DESCRIPTION OF PROJECT: Demolition of building and construction of a new, mixed-used development

Current DA: 2019/1475

We refer to council's letter correspondence dated 22/3/2020. In response to matters raised within the letter, we provide our response below & attach amended architectural drawings.

Approved DA Basement 1 Plan

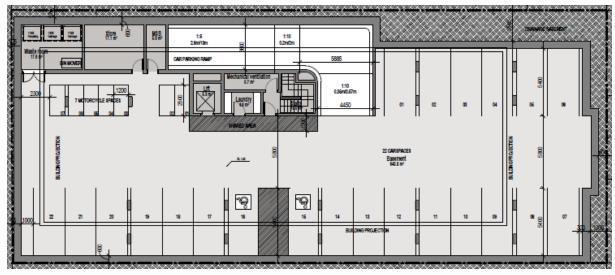
The DA approval (167/2015) permits the current driveway access arrangements. There are no proposed changes to the approved DA traffic arrangements. The 3.6m wide driveway is acceptable with low vehicular volumes, such as what has been proposed here. TTM have recommended a warning system to let drivers know when a car is coming in the opposite direction. This is a very common solution.
